SUBJECT: REQUEST FOR ADDITIONAL INFORMATION FOR THE REVIEW OF THE  
MODEL NO. HI-STAR 100MB PACKAGE

**Request for Additional Information**  
**HOLTEC INTERNATIONAL**  
**Docket No. 71-9378**  
**Model No. HI-STAR 100MB Package**

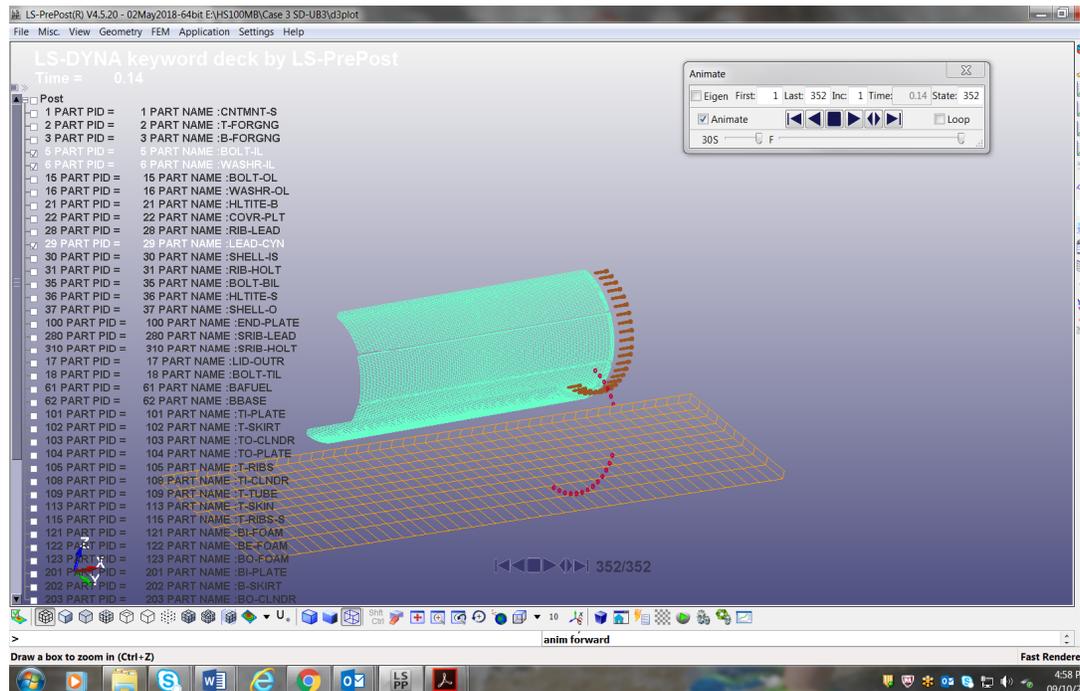
- 4-1 Define clearly the containment boundaries, in Section 4.1 and 4.1.4, to be consistent with the containment boundary shown in Figure 4.1.2 for a single lid cask.

The staff reviewed the containment boundary shown in Figure 4.1.1 for the dual lid cask and the containment boundary shown in Figure 4.1.2 for the single lid cask and finds inconsistencies in the containment boundary.

In particular, the containment components of the vent and drain port cover plates are not marked in Figure 4.1.2; the test port cover (and its test plug seal), marked in Figure 4.1.2, is not identified as the containment boundary.
